# ***SERVICE PROCEDURE***

G-04510-R1  
February 2006

**SUBJECT:** SAFETY RECALL (U.S., EXPORT)  
BATTERY CABLES on certain HPV models built  
11/20/2000 thru 5/20/2004 with Cummins,  
Caterpillar or International DT/HT530 engines.

## **REVISION DESCRIPTION**

**Figure 1 – Engine Removed for Clarity**

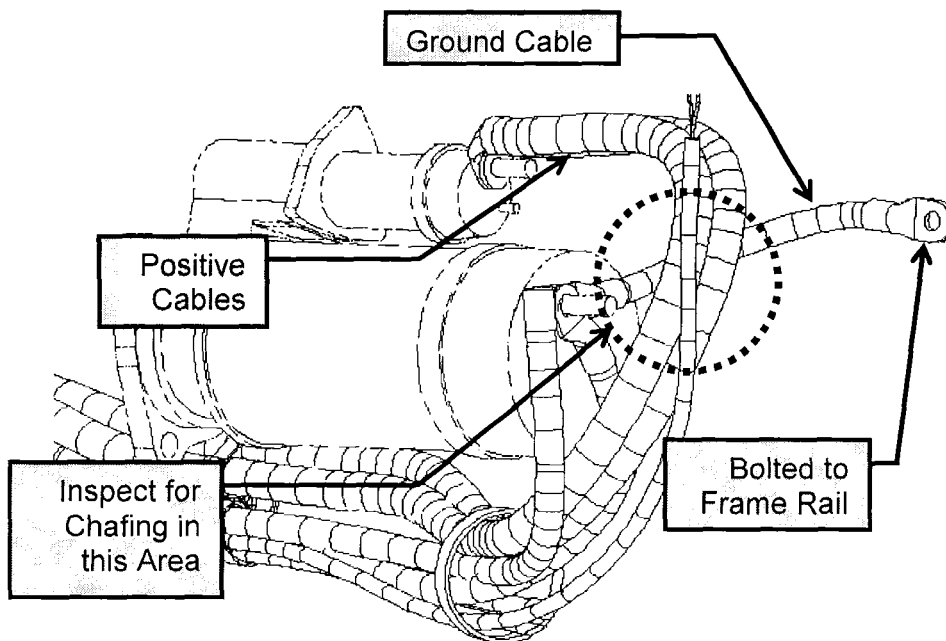
1. Inspect positive (red) battery cables, conduit and ground cable (black) in areas indicated below:

2. If ANY indication of chafing or rubbing is evident, replace any affected cables and continue to step 4.

**Figure 2**

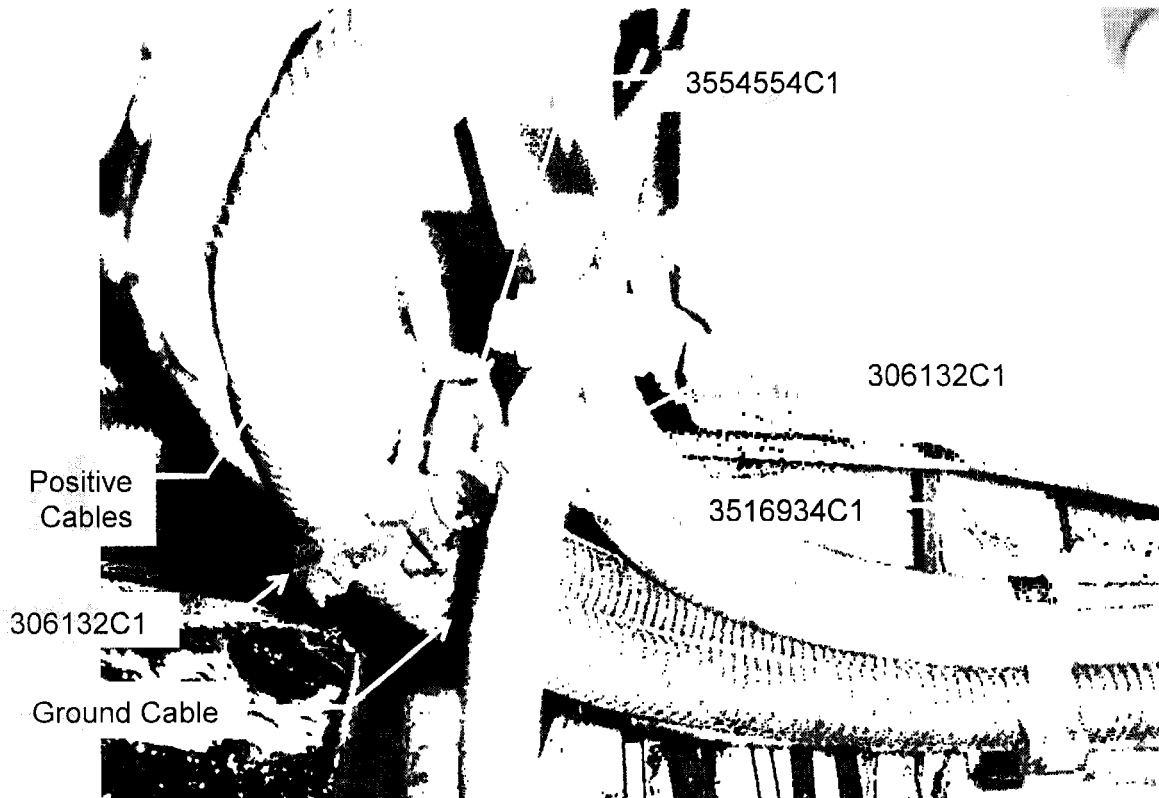
4. Install saddle clamp and strap-locks as indicated below:

Figure 4 – Correct CAT (non-C15) engine block ground cable routing.

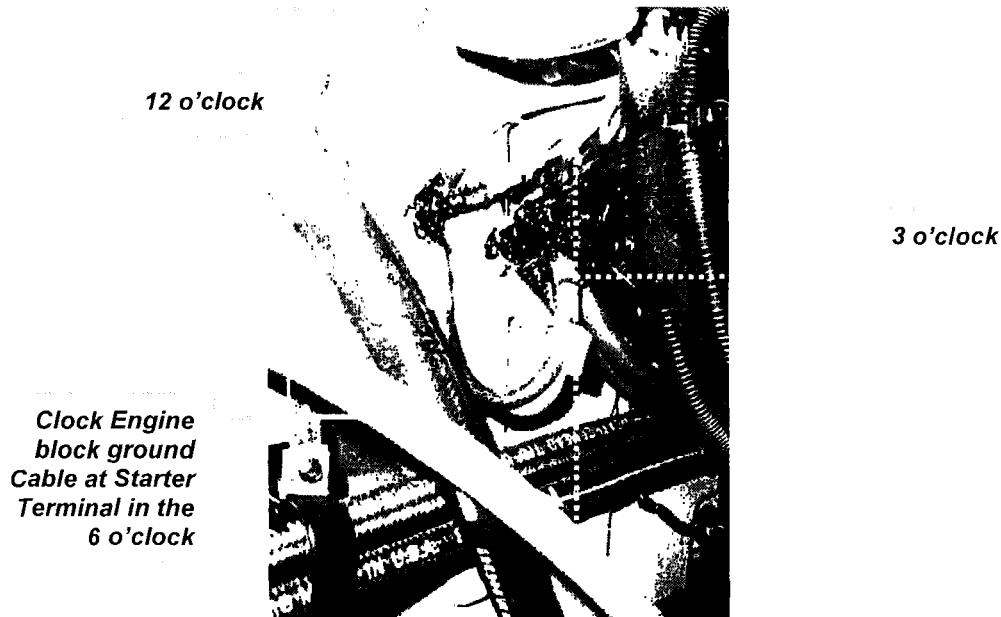
**TO PREVENT CHAFING OF THE POSITIVE CABLES AGAINST THE ENGINE BLOCK GROUND CABLE (SEE FIGURE 3), PLEASE ENSURE ENGINE BLOCK GROUND CABLE IS CLOCKED IN THE DOWNWARD (6 O'CLOCK) POSITION, SEE FIGURE 4.**

- ***If rubbing or chafing of the ENGINE GROUND cable against the Battery Cables is present***, rotate and tighten the new ground cable on the starter terminal so it is straight down (6 o'clock position) and *not* contacting the starter positive cables, see figure 4.

**Figure 5 – Battery Cables to frame rail rub**

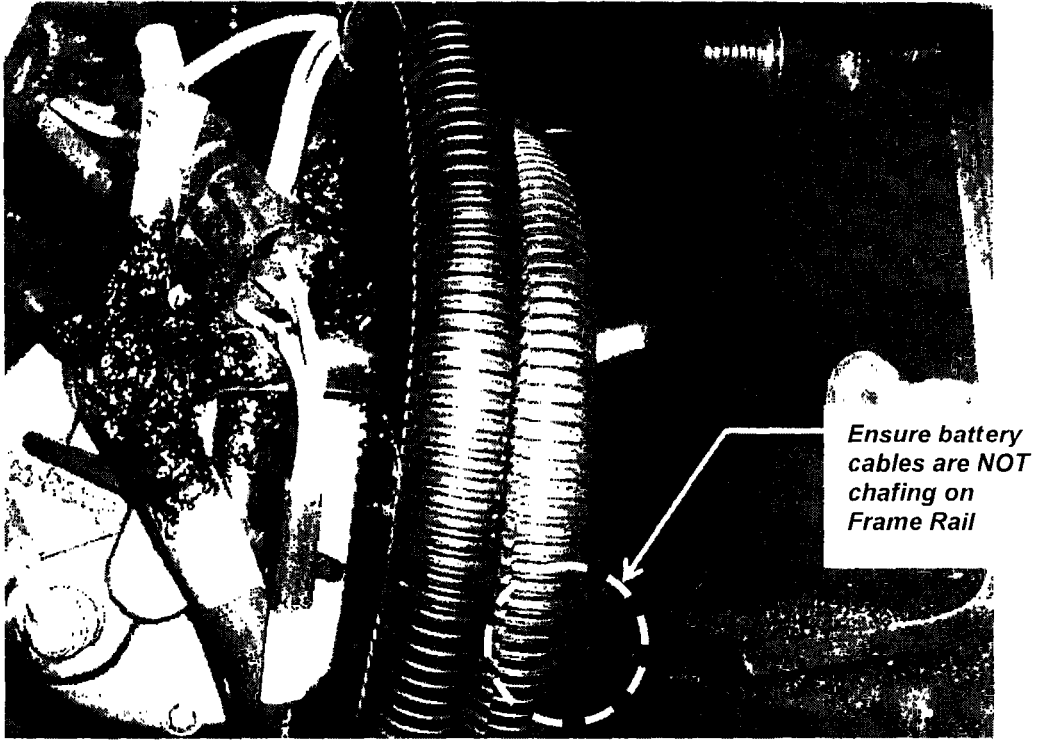
- Regardless of whether or not the saddle clamp was installed, please perform this final inspection on *all* vehicles to ensure the electrical cables are properly routed.
- Please inspect the starter electrical cable routing for rubbing or chafing in the following areas:
  - Battery Cables to frame rail.
  - Battery Cables to FRAME ground cable.
  - Battery Cables to ENGINE BLOCK ground cable .
  - Battery Cables to starter case, starter terminal studs or other starter components and wiring.
  - Battery Positive Cable to BATTERY ground cable.
  - Battery Positive Cable to FUEL FILTER housing.
- It may be necessary to loosen and/or remove a battery cable to re-orient it.
- It may also be necessary to loosen/replace routing/clipping points (p-clamps, extension clips, etc...) to facilitate a no-rub condition.
- See figures below for a representation of rub conditions that require remedied.
